CITY OF ALBUQUERQUE

RE: **Chipotle**
4331 San Mateo NE
Grading Plan Stamp Date: 10/16/19
Hydrology File: G17D032

Based on the submittal received on 10/18/19, this project cannot be approved until the following corrections are made:

Drainage Management Plan

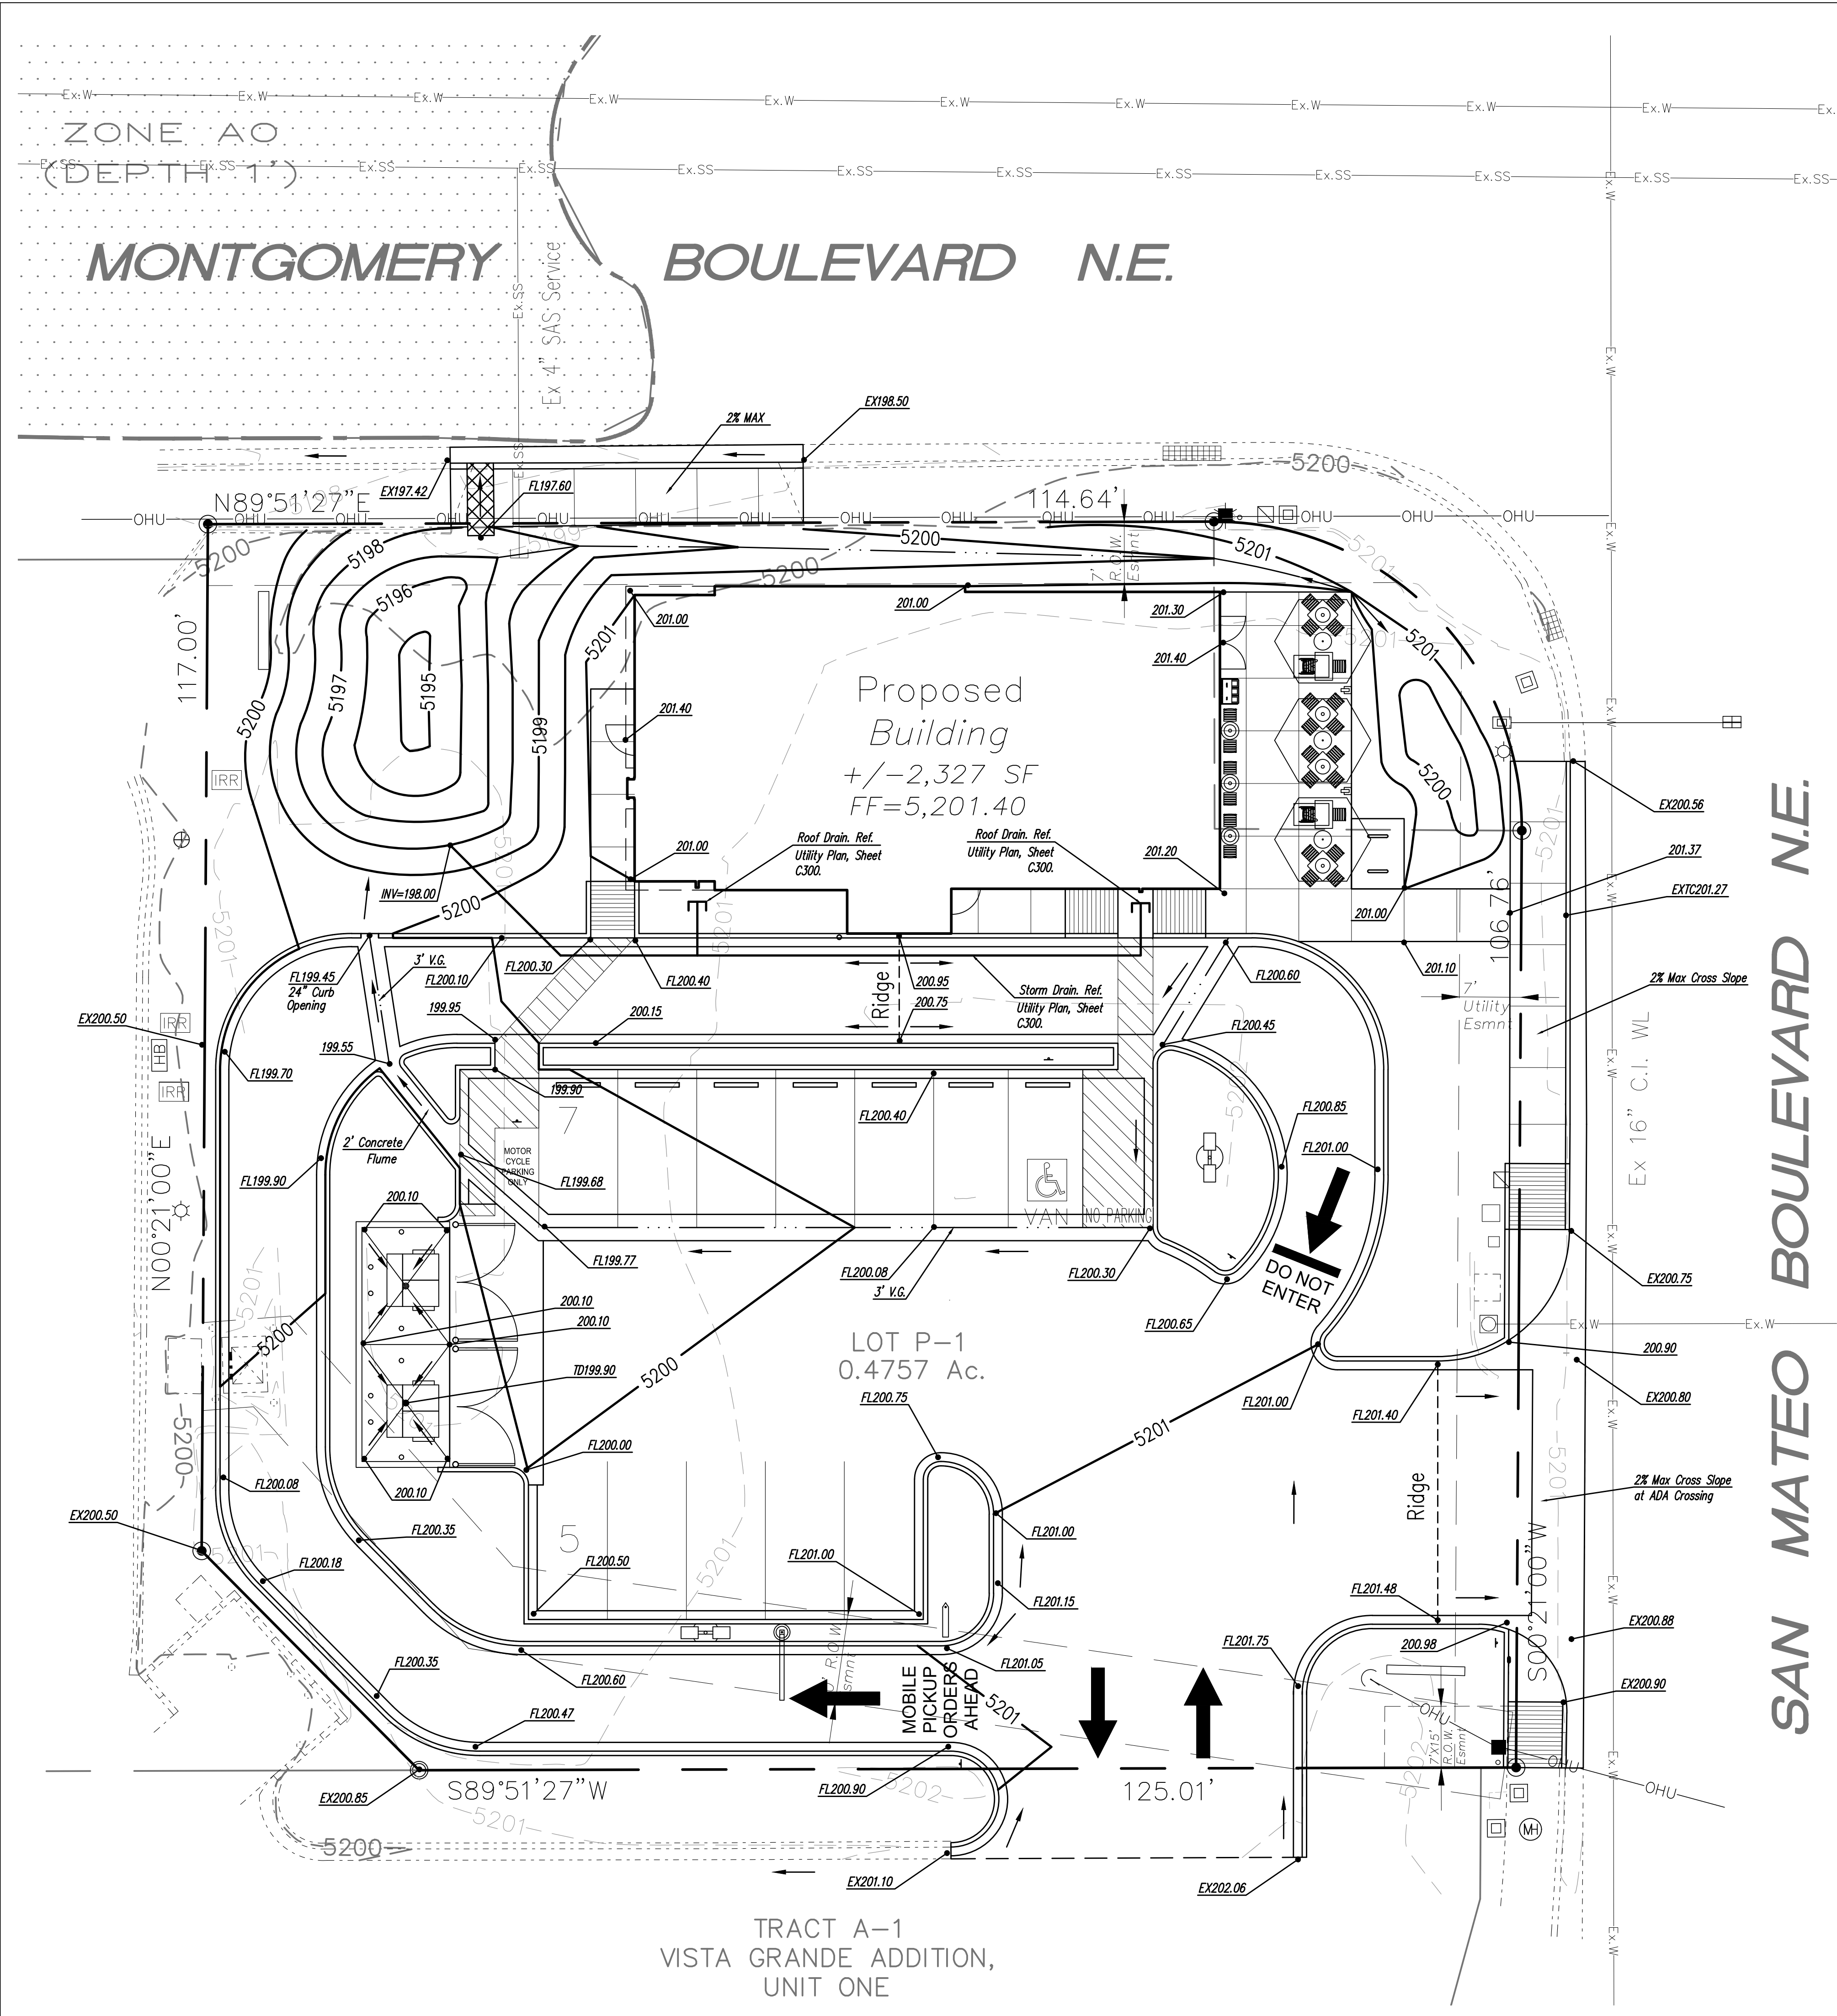
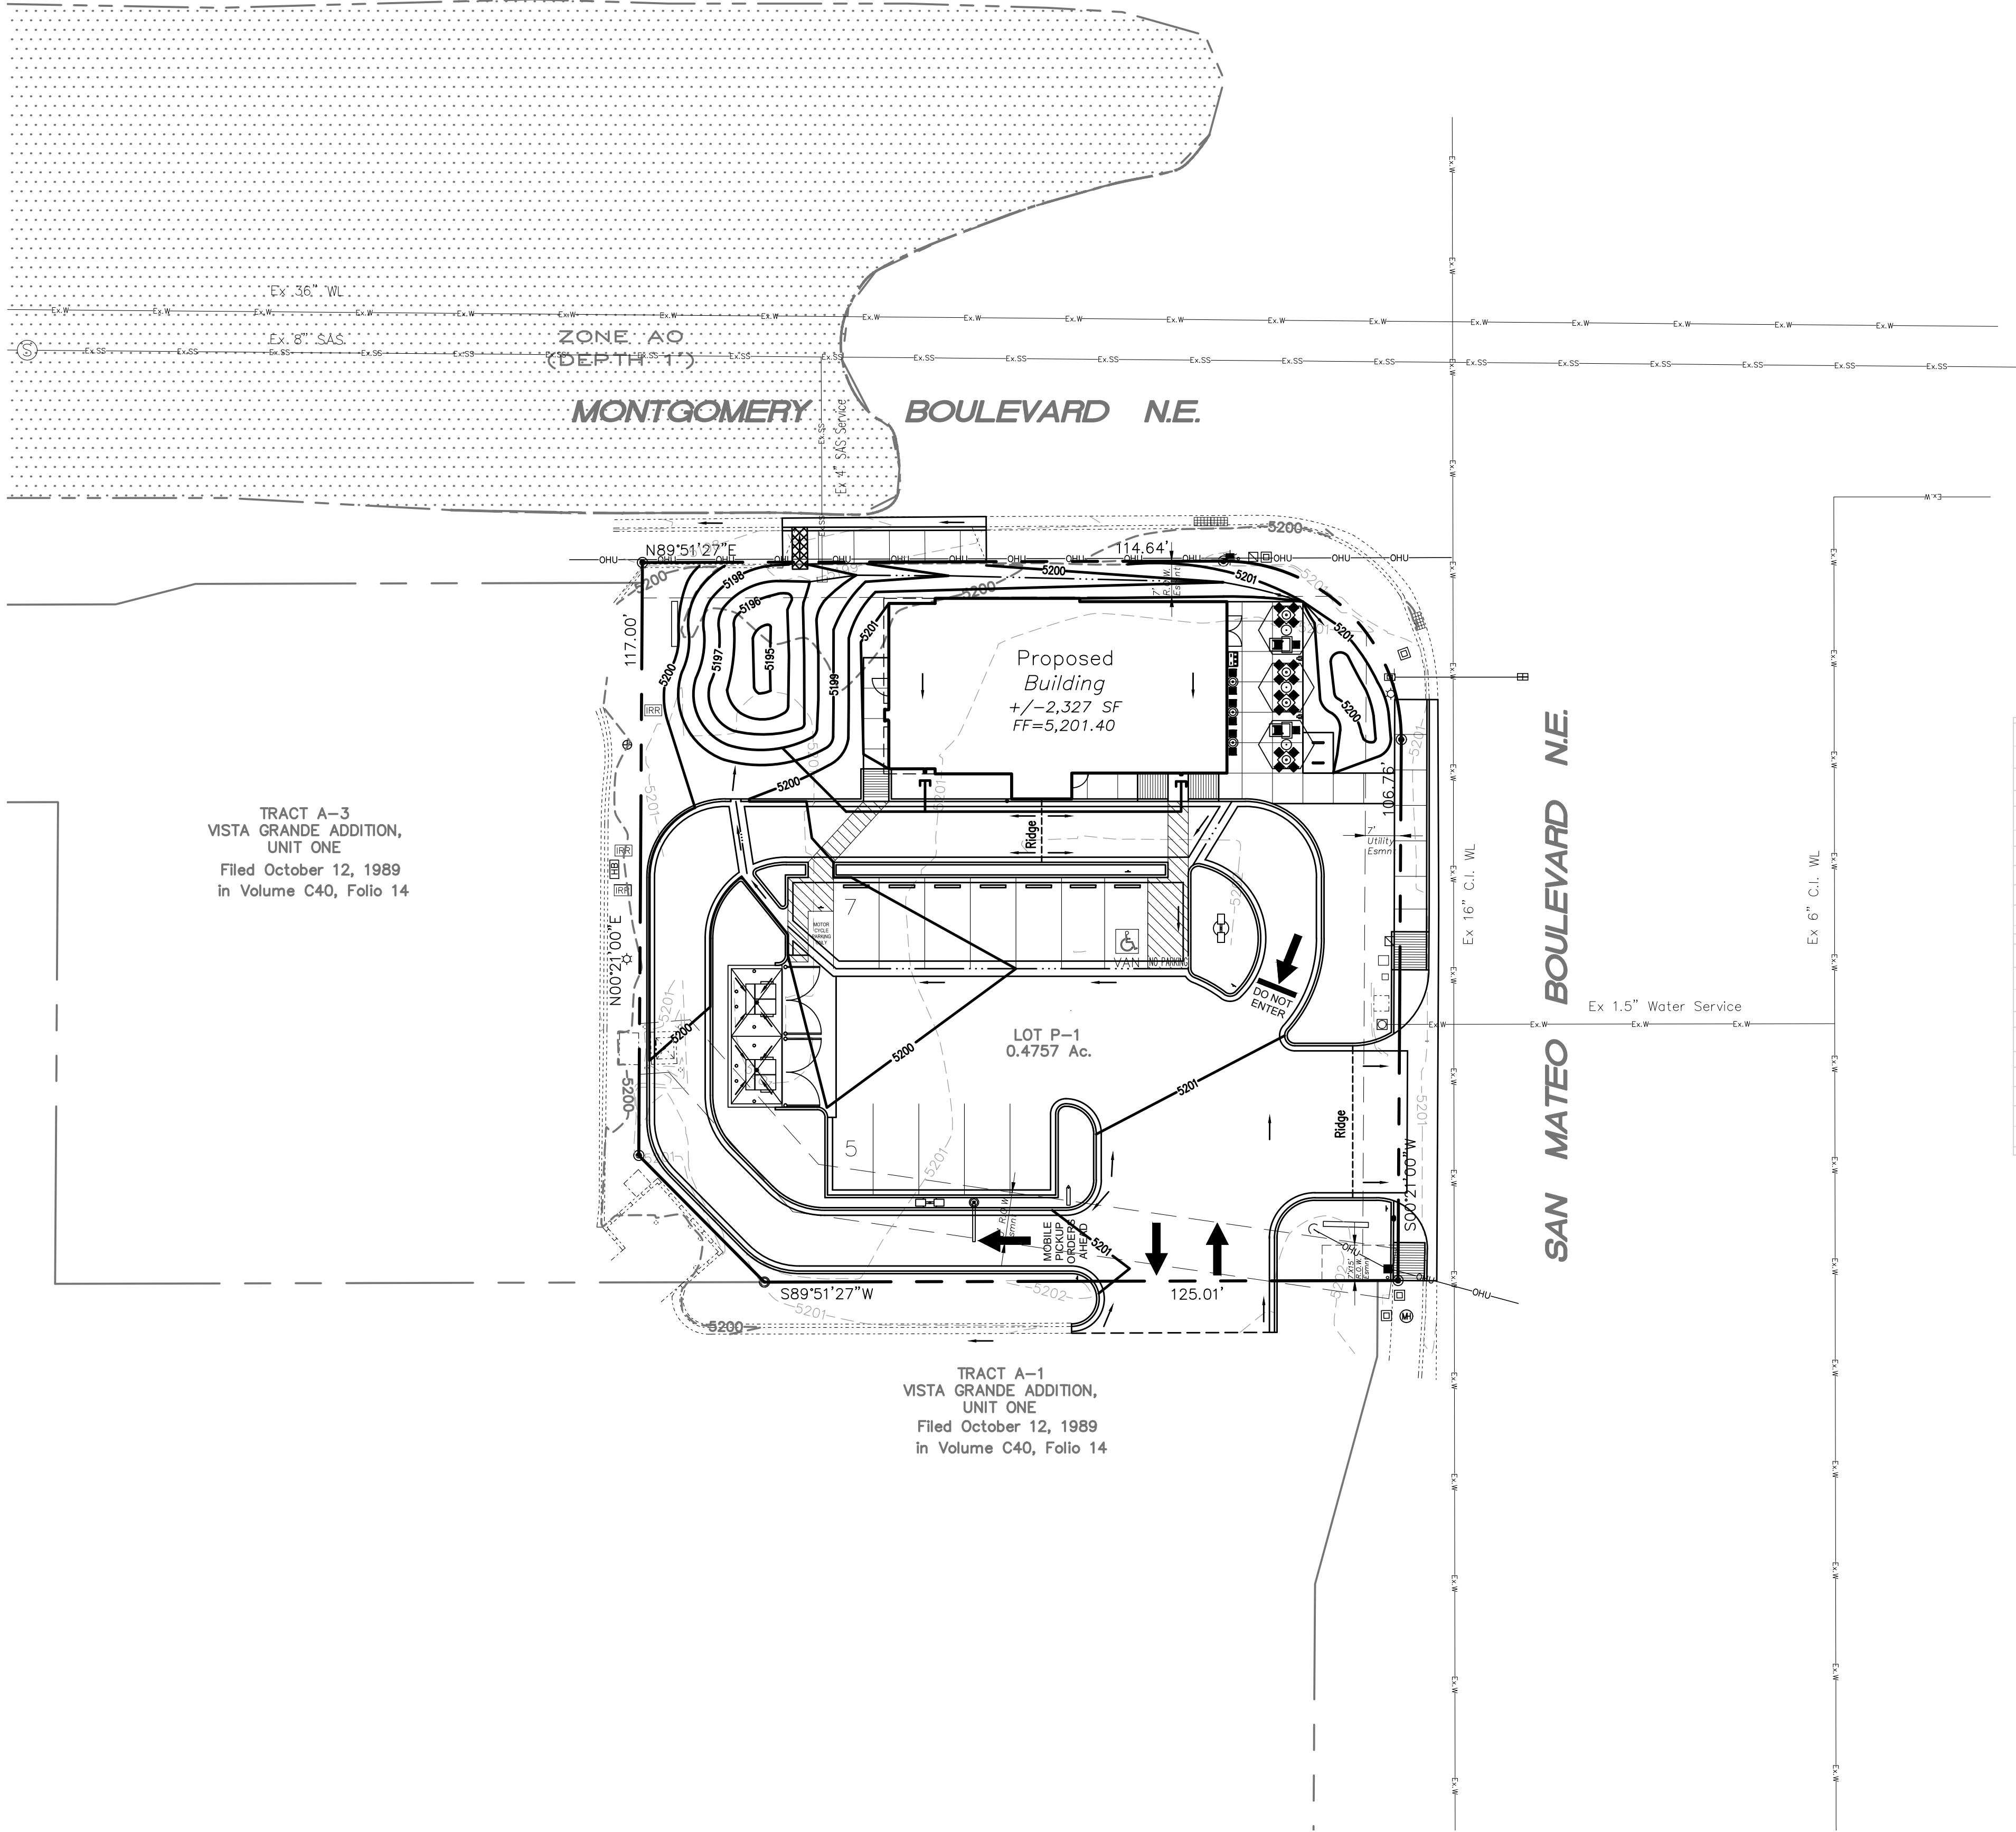
1. Provide written and signed permission from the adjoining property owner for work on their property (curb and pavement on the southern access aisle).
2. An SO-19 Permit will be required and should be included on the request. Please include the [standard SO-19](#) notes on the grading plan.
3. Include project benchmark and datum; all existing survey, proposed grades, and benchmarks must be provided in NAVD 88.
4. Because these corrections are minor, the administrative resubmittal fee of \$40 may be used. Please include a copy of this letter when resubmitting in order to receive the reduced fee.

5. Engineer's Certification, per the DPM Chapter 22.7: *Engineer's Certification Checklist For Non-Subdivision is required.*
6. The sidewalk culvert must be inspected and approved by Storm Drain Maintenance (Augie Armijo at (505) 857-8607).
7. A Bernalillo County Recorded [Drainage Covenant \(No Public Easement\)](#) is required for the stormwater pond. The original notarized form, exhibit A (legible on 8.5x11 paper), and
